# FINAL ENVIRONMENTAL IMPACT STATEMENT

## ***LeCount Square*** *New Rochelle, New York*

**Date of Acceptance:** October 16, 2008

Exhibit 25  
**FEIS  
 OPEN SPACE  
 DEVELOPMENT PLAN**

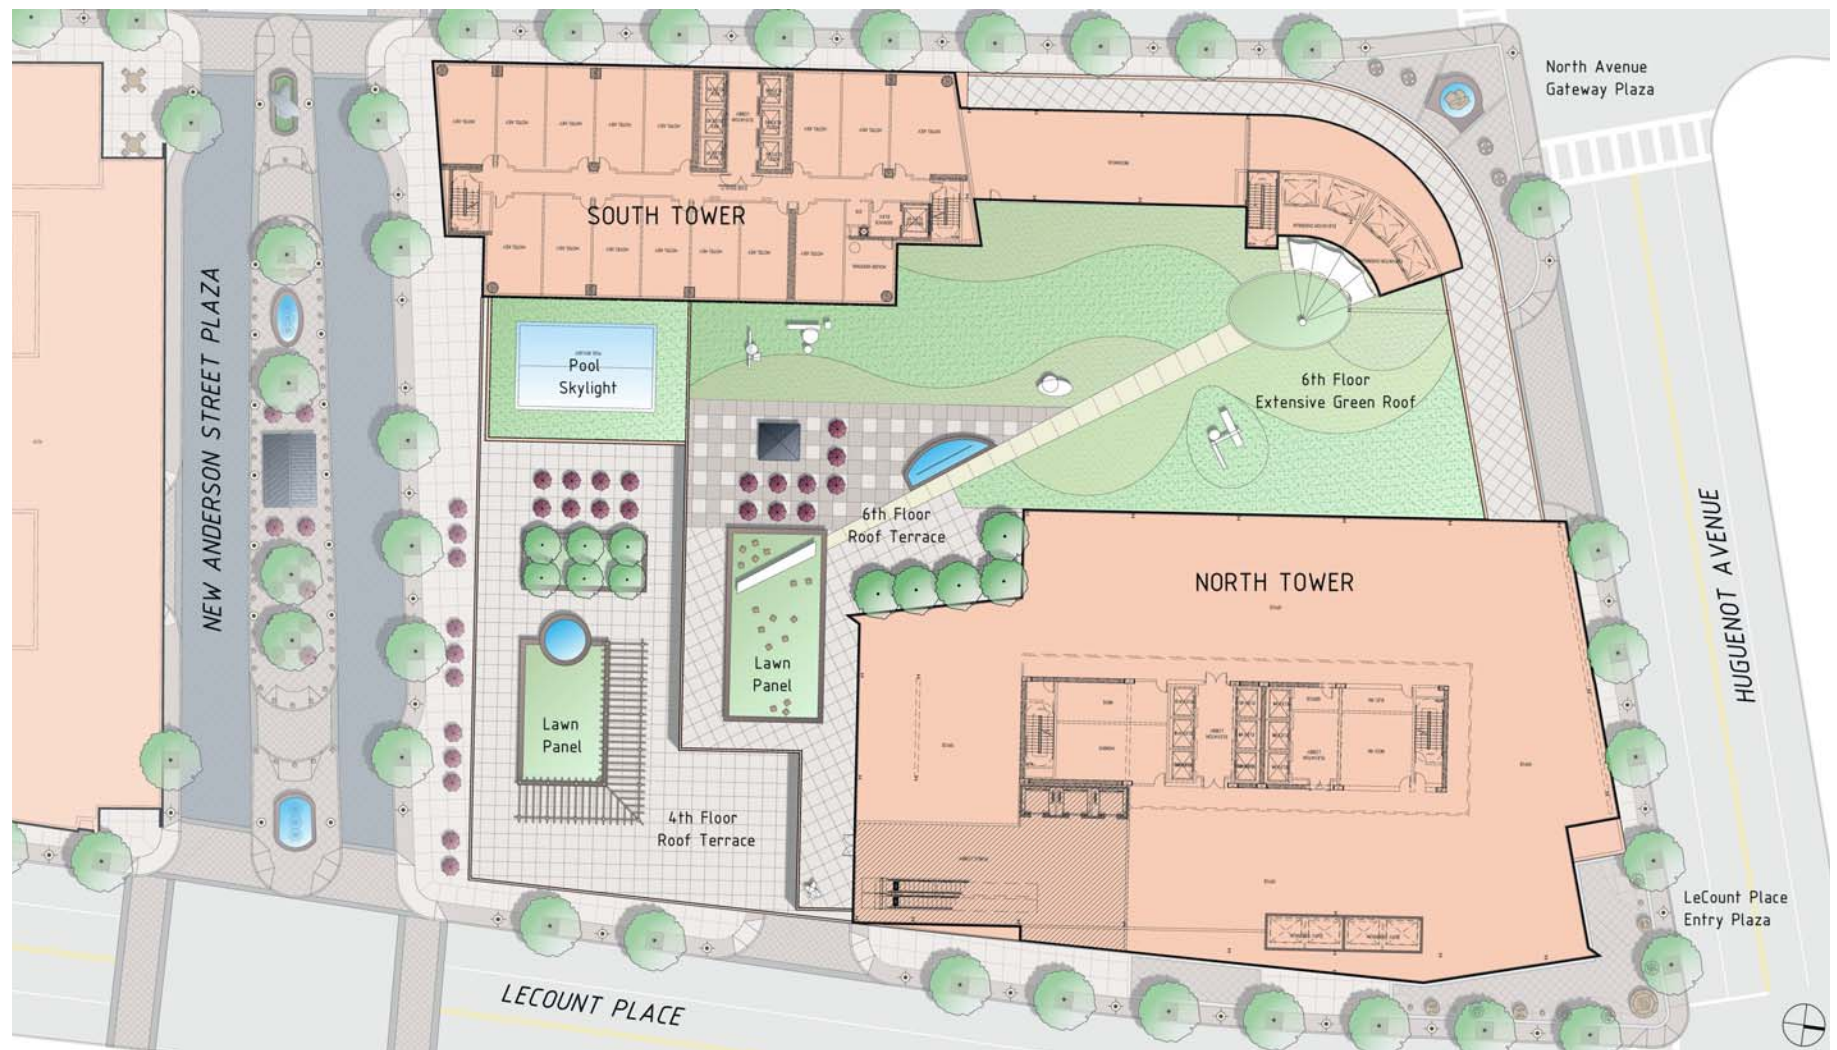
In response to City concern regarding the potential that fourth floor terrace use by the hotel could temporarily restrict public access to the terrace, this area has been eliminated from the calculation of on-site public open space. However, the terrace would have access from the public atrium and would provide a public open space resource when not in use for hotel functions. The designs for the upper terraces have evolved, but retain the same components and design principles described in the SDEIS. The overall concept for the publicly-accessible open space remains the "Gallery at LeCount Square," a place to showcase public art in a park setting. The most current proposals for the roof terraces are shown on Exhibit 25. The fourth floor terrace is envisioned to

include a hardscape area, shade tree plantings, a water feature, pergola and café-style seating and would total approximately 9,220 square feet. The sixth floor terrace would similarly contain a hardscape plaza with tree plantings, a lawn panel, movable seating, a concession kiosk, and café-style seating. It would also contain an extensive green roof component, with sculpture garden and a walking path. The green roof provides an additional type of open space, helping create a diversity of open space experiences. The terrace would be a flexible space capable of accommodating larger groups for programmed events such as gallery openings or musical events, as well as informal passive recreation for small groups or individuals, away from the noise of the streets below. The sixth floor open space totals approximately 21,850 square feet.
